NEBRASKA CAPITOL ENVIRONS COMMISSION

NEBRASKA CAPITOL ENVIRONS COMMISSION STAFF REPORT

APPLICATION NUMBER	Urban Design Record #22119
APPLICATION TYPE	Certificate of Appropriateness
ADDRESS/LOCATION	G Street (S 13th and S 17th Streets), and J Street (S 16th and S 21st Streets) in the Nebraska Capitol Environs District
HEARING DATE	December 23, 2022
APPLICANT	Craig Aldridge, 402-416-5349, caldridge@lincoln.ne.gov
STAFF CONTACT	Collin Christopher, 402-441-6370, cchristopher@lincoln.ne.gov

APPLICATION NUMBER	Urban Design Record #22073
APPLICATION TYPE	Certificate of Appropriateness (Received July 22, 2022)
ADDRESS/LOCATION	1821/1843 K Street
HEARING DATE	December 23, 2022
APPLICANT	Greg Newport, 402-430-5631, greg.newport@outlook.com
STAFF CONTACT	Collin Christopher, 402-441-6370, cchristopher@lincoln.ne.gov

ATTACHMENT A G STREET STONE CURB REMOVAL FROM S 16TH – S 17TH STREETS

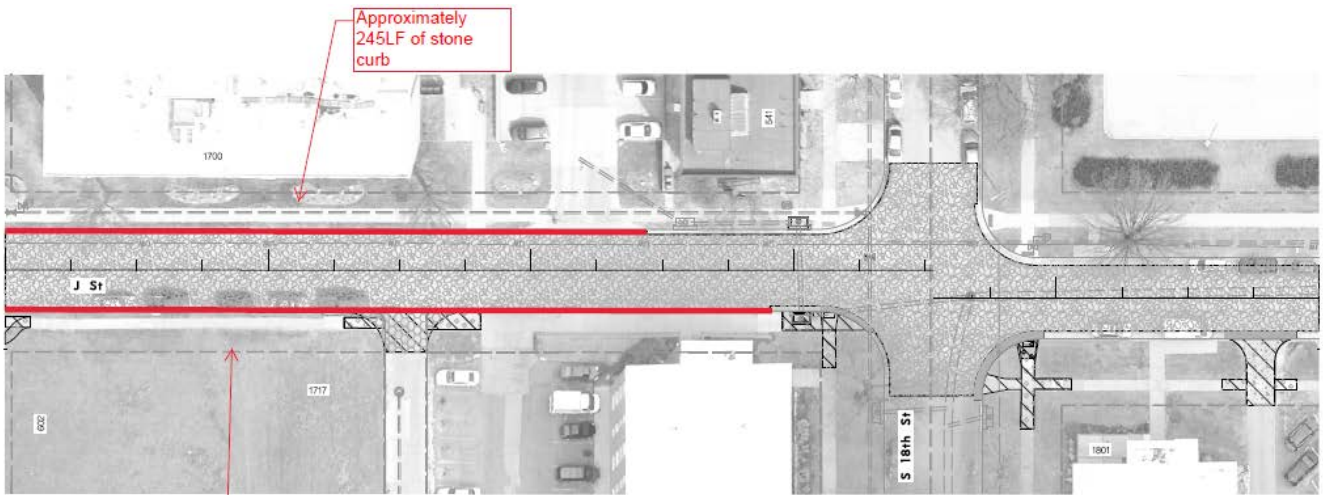
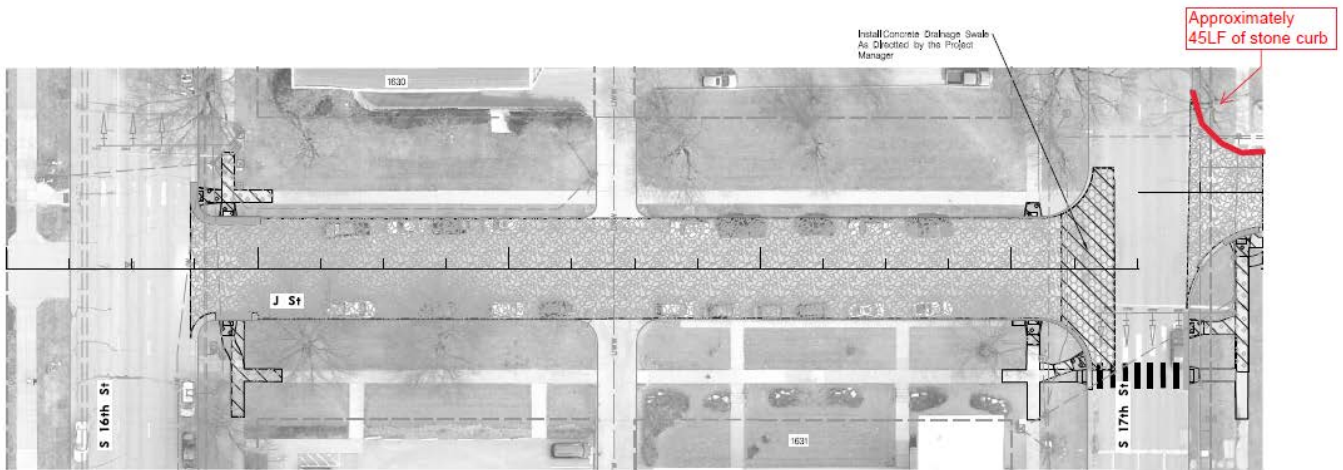
Attachments A and B at the end of this report detail the areas within the Capitol Environs District – G Street from S 16th to S 17th and J Street from S 17th to S 18th Streets – that will be impacted by the stone curb removal. At the November NCEC meeting, LTU staff provided an overview of the project and the plan for removing the stone curb in question.

Recommended action: Approval of a Certificate of Appropriateness for the the removal of the sandstone curbs, and the construction of concrete curbs to replace them, with the following condition:

1. LTU staff shall work with staff from the Capitol to ensure the reuse of as much of the stone curb as possible. If Capitol staff declines to take the removed stone curb, LTU shall coordinate with the City's Planning Department to attempt to find a use for the material in a future streetscape or park project.

CONSTRUCTION AND REMOVAL

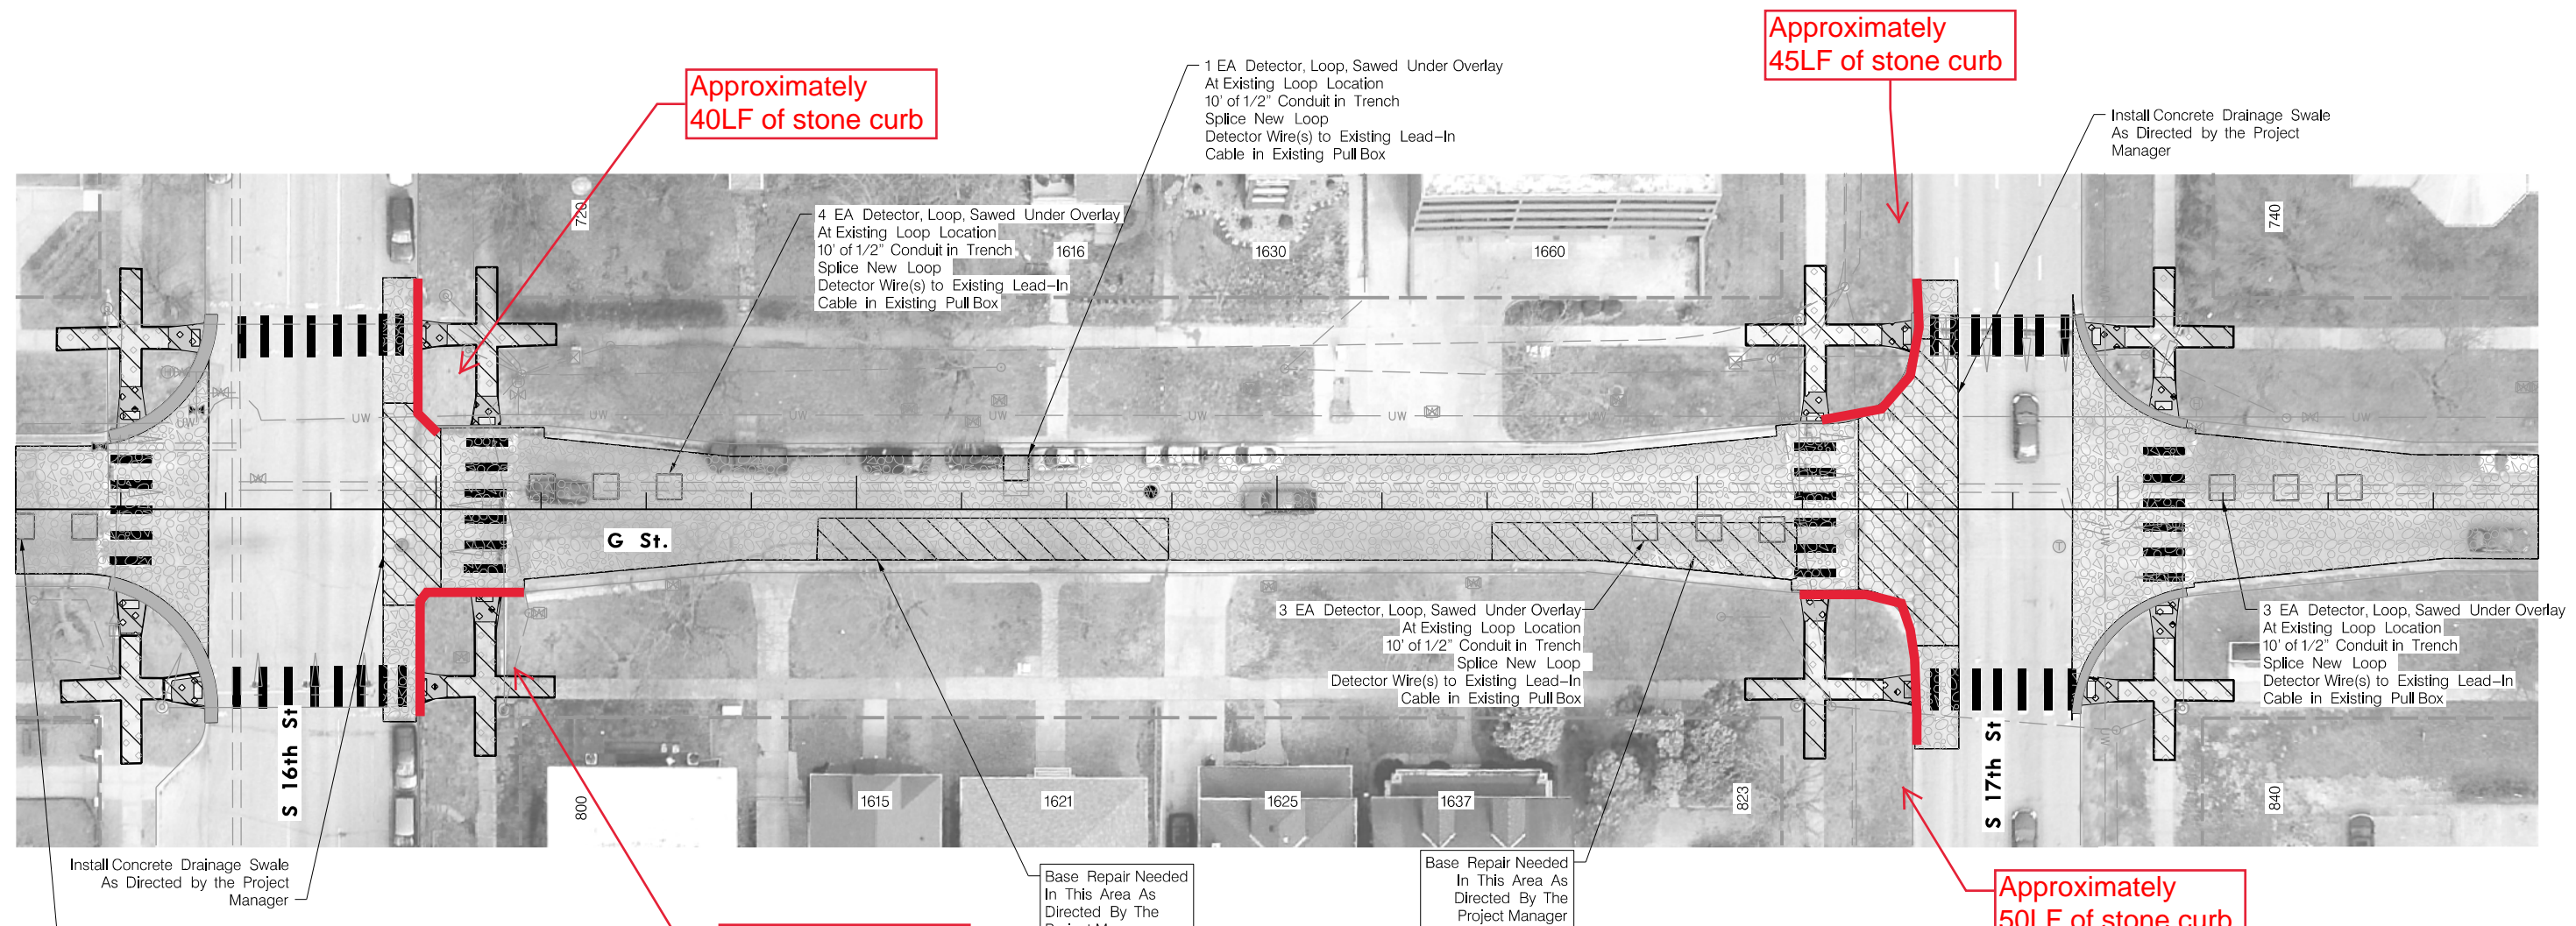
Approximately
60LF of stone curb

Approximately
50LF of stone curb

CONSTRUCTION AND REMOVAL

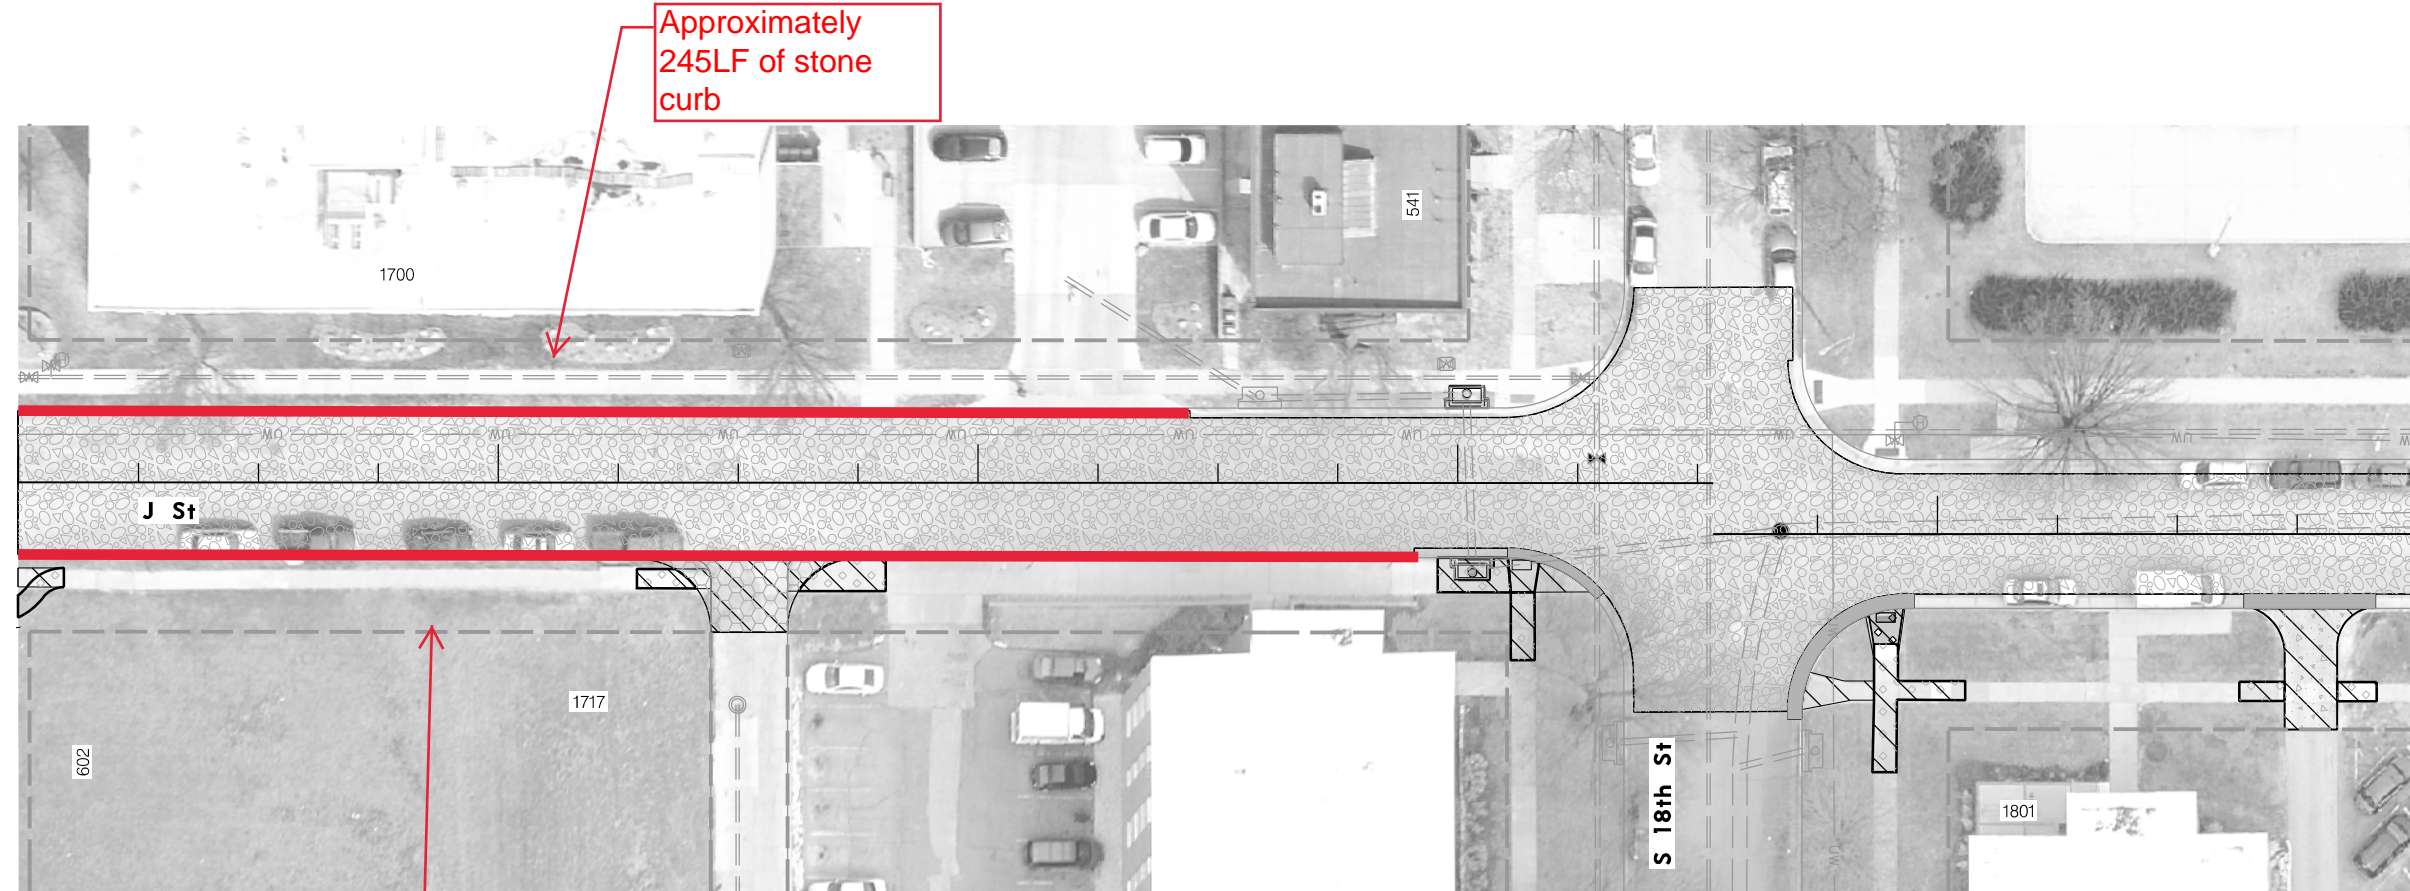
Approximately
290LF of stone
curb

Approximately
245LF of stone
curb

ATTACHMENT A
ORIGINAL TRAFFIC BARRIER ILLUSTRATION

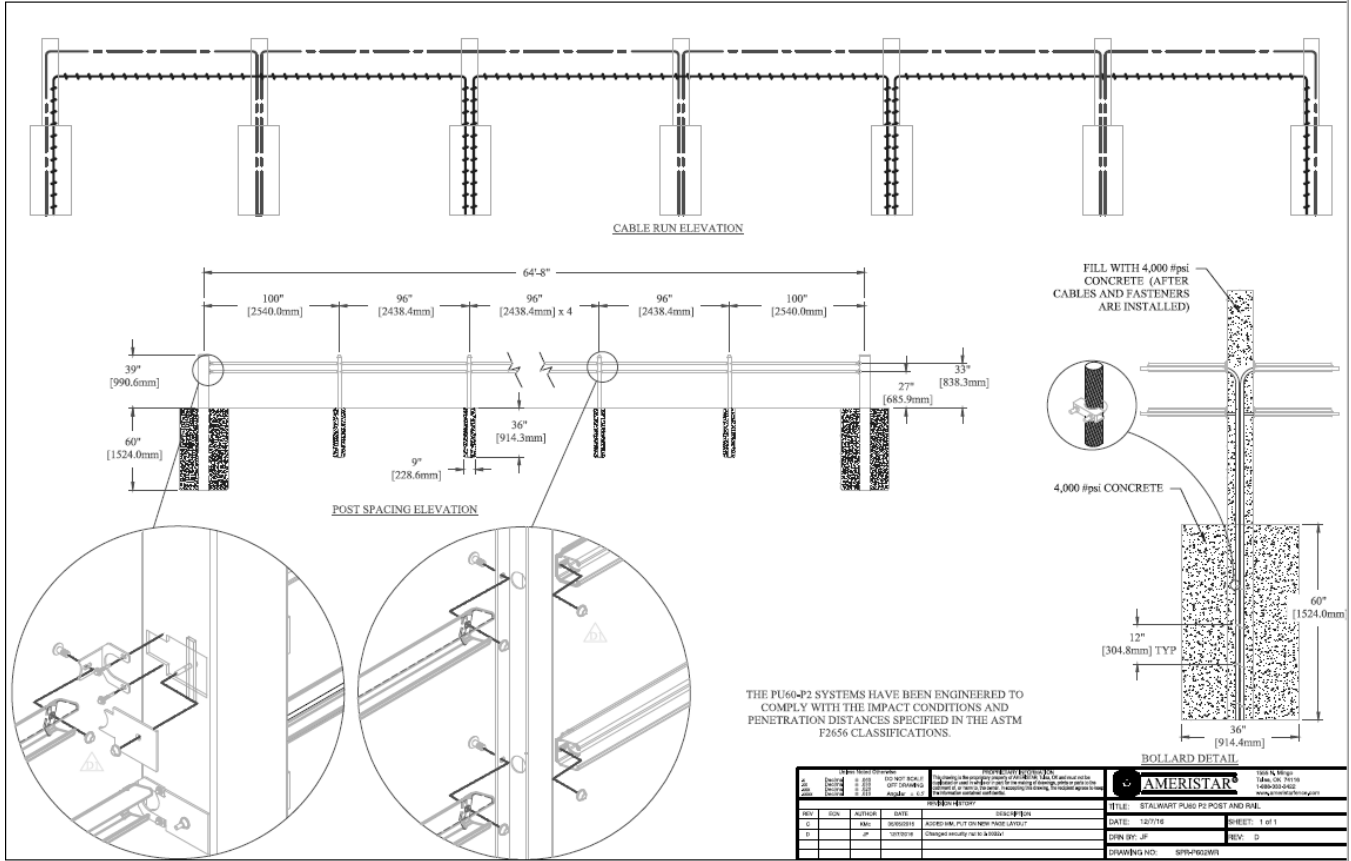
The applicant has since changed the design of the traffic barrier system and is seeking an updated certificate. The new barrier system design eliminates the spherical barriers and replaces them with a cable restraint system that will be landscaped to offset any negative visual impacts.

The new design fits into much of the same scenario, where durability and quality are of primary concern. Because landscaping is now being introduced, the consideration of landscape maintenance and replacement is also of relevance, as highlighted in Design Standard 27.

Recommended action: Approval of a Certificate of Appropriateness for the proposed site work at 1821 K Street, under the condition that the applicant provide the Commission a landscape plan for review prior to planting.
